Product Change Notification

PCN-A-1050325

Change the golden Connector on the Vehicle dock and the Computer part for FM10 / FM08

Original Golden Connector on the Vehicle Dock	NEW Golden Connector Design on the Vehicle dock

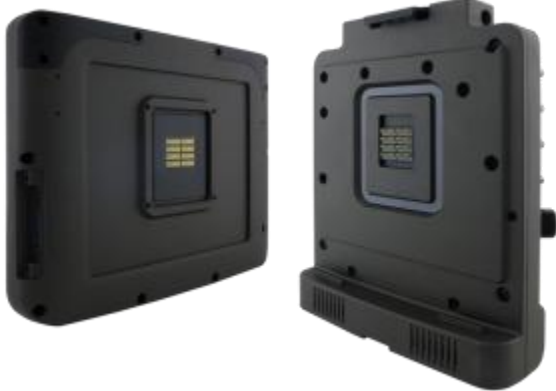
To improve better performance of external antenna, the Golden Connector on the Vehicle dock of FM10 and FM08 has been changed. The antenna signal has moved into the pogo/ machine pin part. The new dock works only for the new computer part.

Original Golden Connector on the Computer FM10/FM08	NEW Golden Connector Design on the Computer FM10/FM08

The original computer part and the new docking part (or original docking and the new computer part) **cannot cross matched.**

Original Computer part can be paired only with Original Docking part	New Computer part can be paired only with New Docking part
